### **Submission of Further Information**

**S. 12A Application for  
Rezoning Application from “AGR” and “GB” to “OU (Columbarium)”  
Various Lots in D.D. 41  
and Adjoining Government Land, Tong To, Sha Tau Kok, N.T.**

We would like to submit an updated TIA report with RtC (same as the report and RtC uploaded to share drive on 28.1.2026) and a set of RtC to respond to the comments from TD, AFCD, DLON and HyD for the captioned application.

金塔屋編號: NDO – 2780-99

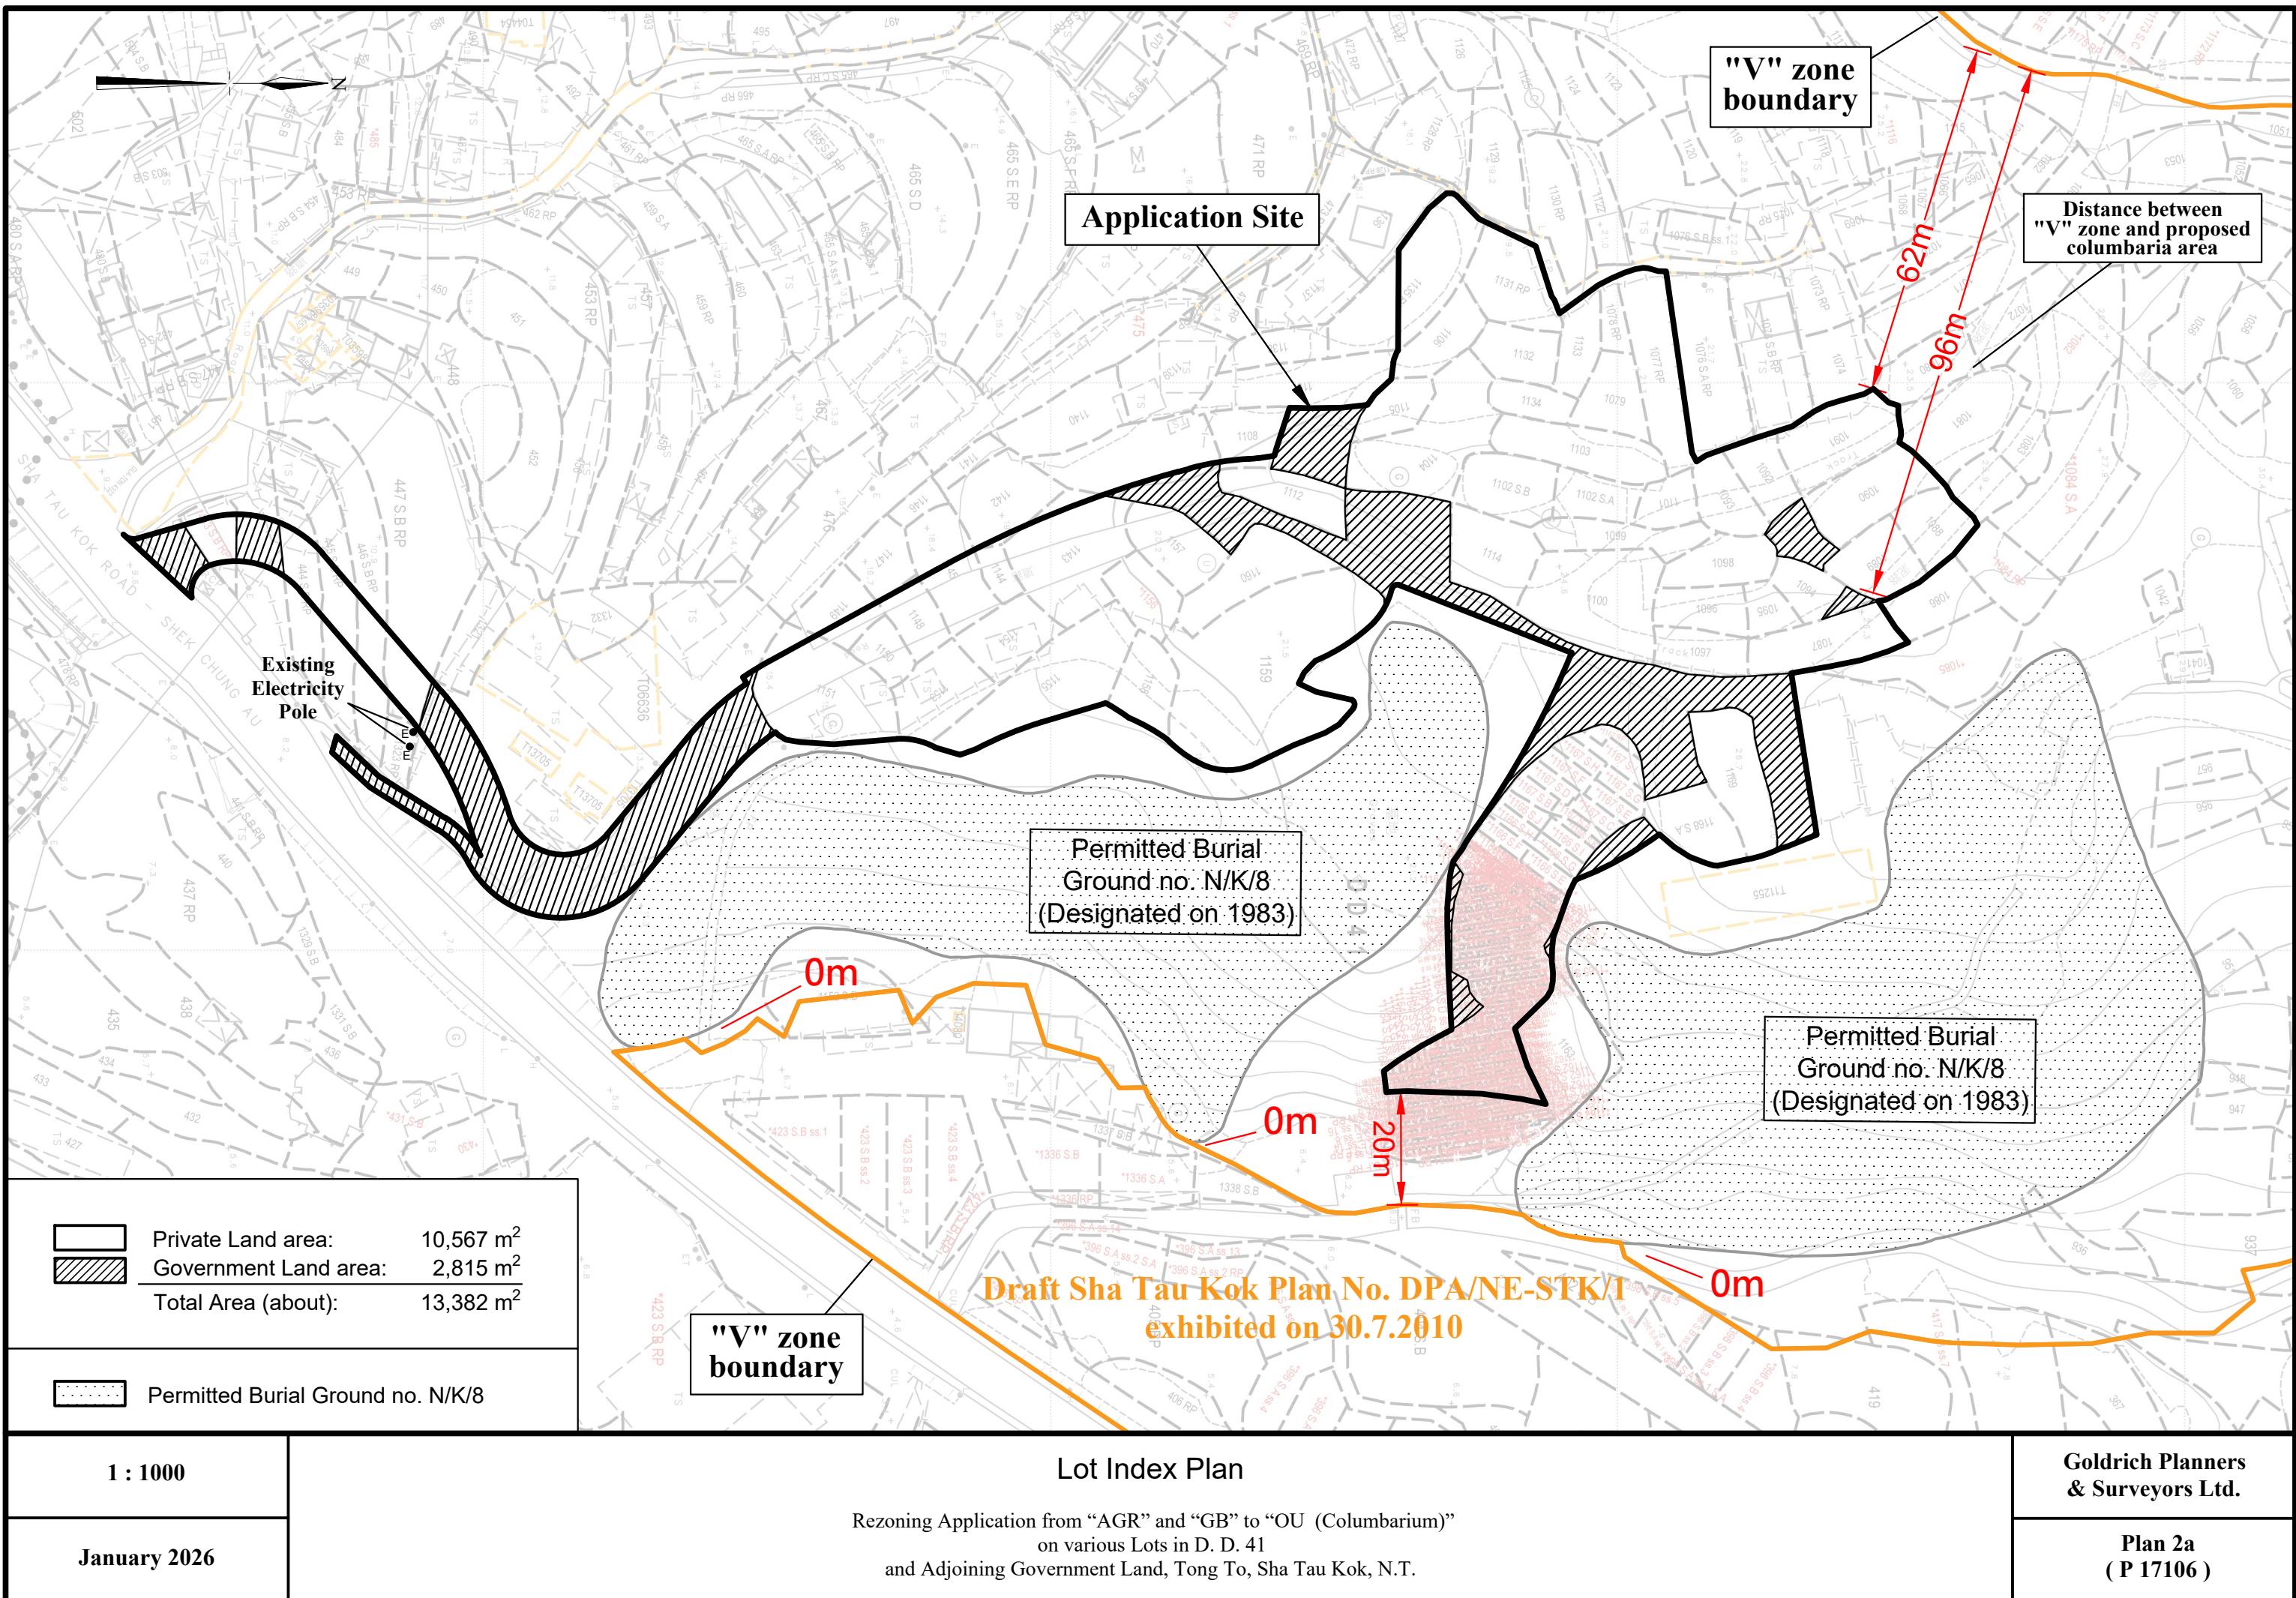
Comments	Responses
<b><u>Inclusion of Government Land (GL)</u></b>	
<p>For point 14 of the Response-to-comment to LandsD (“the R-to-C”), it was observed during our re-inspection on 12.1.2026 that an empty urn shelter bearing number “NDO-2780-99” was found on GL within the application site. You may seek DO(N)’s comment in this regard. In particular, (i) whether approval has been given by DO(N) for the burial thereat; (ii) presumably there is no human remains buried underground. You may further clarify with DO(N); (iii) whether there is any record of urn removal according to DO(N)’s record, and (iv) whether DO(N) has any comment on the proposed removal and the removal arrangement of the urn shelter.</p>	<p>The empty urn shelter has been removed. Please find attached letter from the owner of the empty urn shelter and four photographs for details.</p>
<p>The applicant focused on the arrangement of the urn shelter but had not responded to our previous comment (paragraph 5 of our previous memo of 7.1.2026) that “...it is noted some areas of the affected GL, particularly the portions forming the proposed access roads to the proposed development, may not be incapable of reasonable separate alienation or development... the GL included in the application site may not be available/able to be granted for the subject proposal (if applied).”, which remains valid.</p>

北區政署通知本村，然知本祖先金塔屋超越 NK/8 葬區，本人配合民政署要求金塔屋搬遷至指定葬區，以在 10/2025 以將先人金塔遷移到親戚合法金塔屋。

清拆金塔屋一事，未能在年前清拆乃是風土習俗，融重新興建金塔及斂墓，只能在 2026 年清明節後處理。

上周本人家庭會議後，因風水及其它特殊原因，家庭成員決定在 19/01/2026 完成清拆及安墓，亦配合政府要求。
